TECHNICAL SERVICE BULLETIN No. TSB-ENHCV-1524

Subject	Inspection of Ecotorq Transmission Output Coupling Cover Bolts
Model	All Ford Trucks Vehicles with Ecotorq Transmission
Sum	Inspection steps to prevent the output coupling cover bolt from shearing

Image 1- Inspection Area

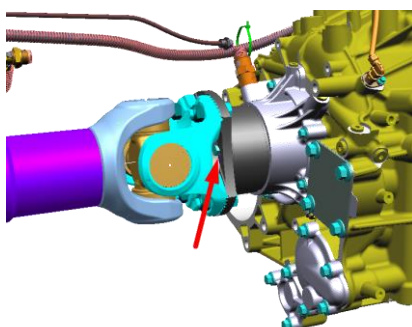
IMPORTANT : For our Ford Trucks vehicles equipped with the domestic Ecotorq transmission, **it is essential to always check the bolts securing the output coupling cover** during each maintenance or when the vehicle enters the service

The inspections to be performed will involve visually checking for bolt loosening and manually checking for torque loosening in the bolts. **No labor should be added to the claim process** for the inspections performed by eye or hand

In case of bolt loosening, missing bolts, or rotation of the bolts during manual inspection, the service procedure outlined below must be fully completed

Image 4- Removal of Nuts

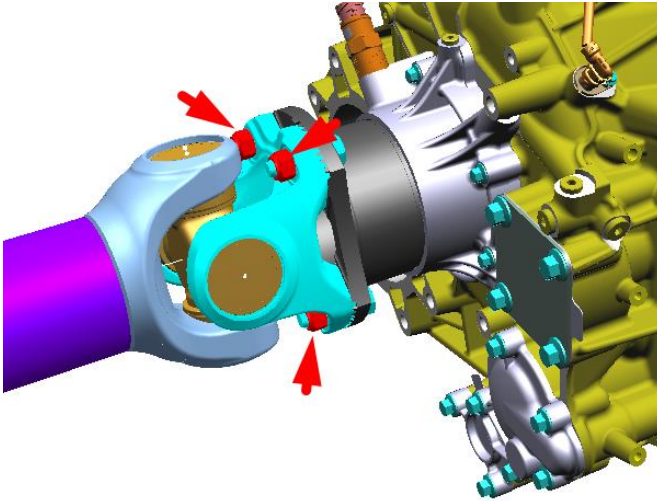
To gain access to the coupling cover fasteners, four W520014-S type nuts and four W718766-S type bolts should be carefully removed. (They are numbered as 1, 2, 3, and 4 on the image)

Image 6- Coupling Cover Bolts

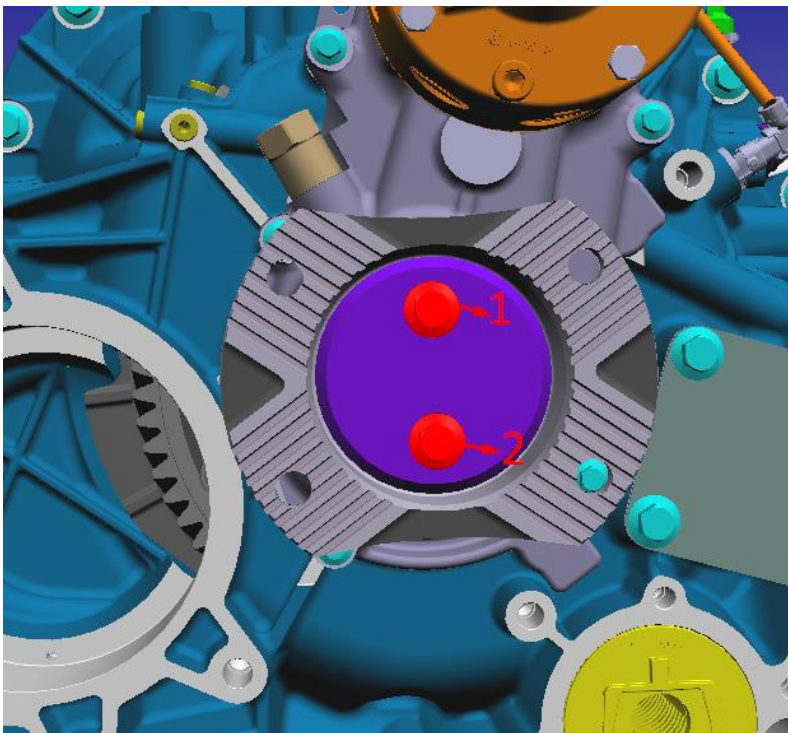
Both bolts are removed. (They are numbered as 1 and 2 on the image.)

Image 8- Coupling in the Correct Position

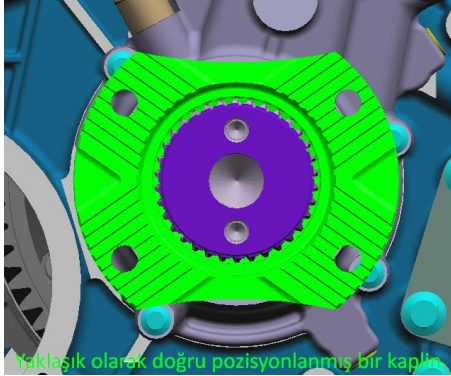
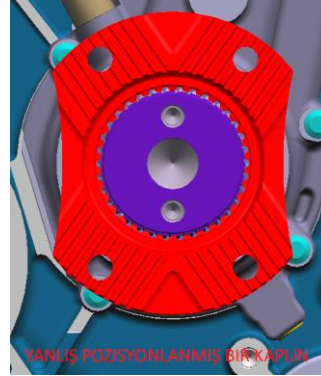
Ensure that the coupling, coupling cover, and bolts are positioned as shown in the image below. Since perfect alignment as shown in the image may not be achievable, a slight deviation is acceptable

Image 10- O-ring position

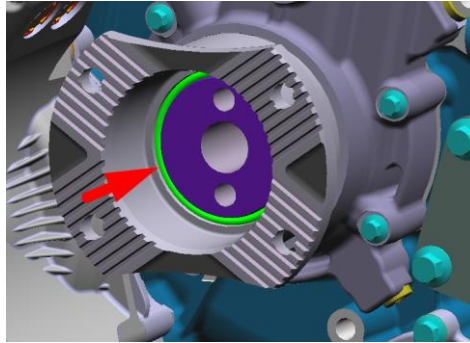
- Make sure that the O-ring sits properly in its groove. Ensure that there is absolutely no overflow in the coupling assembly pressure area.. (LC46-7J030-AA)

Image 11- Bolt and Cover Position

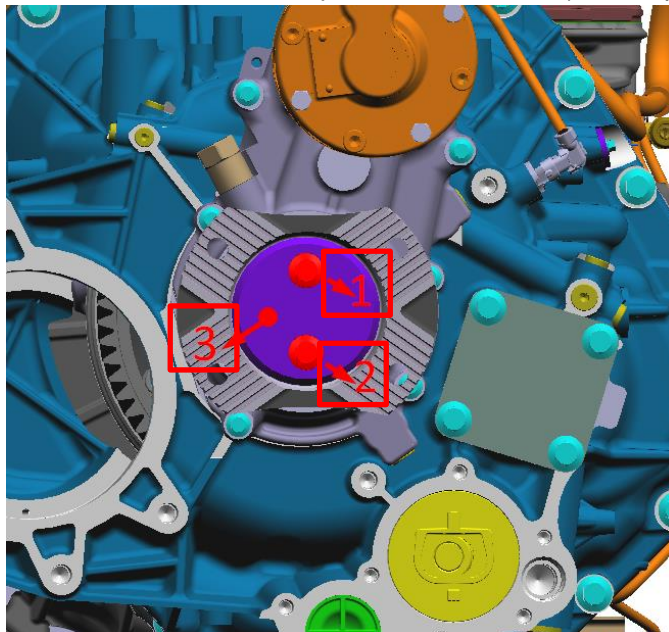
The gap must be taken up until both bolts sit flush with the cover surface.

- Ensure that the coupling cover (number 3) is centered in the assembly area.
- The gap-free bolts numbered 1 and 2 are tightened to 45 ± 5 Nm. (W500543)
- Bolts numbered 1 and 2 are then tightened to 80 ± 5 Nm. (LC46-7A771-CA)
- The tightening process for bolts numbered 1 and 2 is repeated at 80 ± 5 Nm. (This step is critical.)

Image 12- Nut Assembly

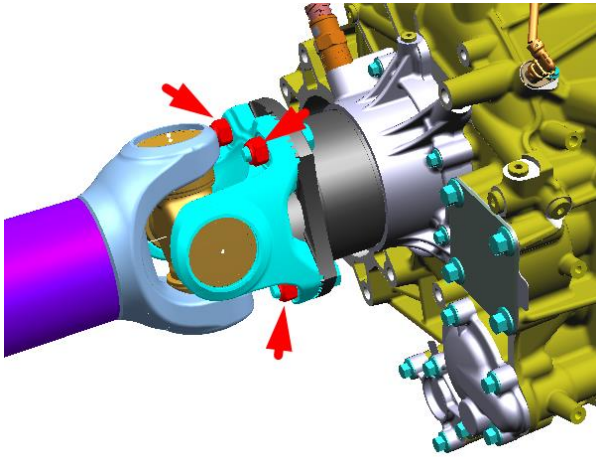
Install the shaft in place. To complete the shaft assembly, tighten 4 pieces of W520014-S (nuts) and 4 pieces of W718766-S to 175 ± 26.3 Nm.
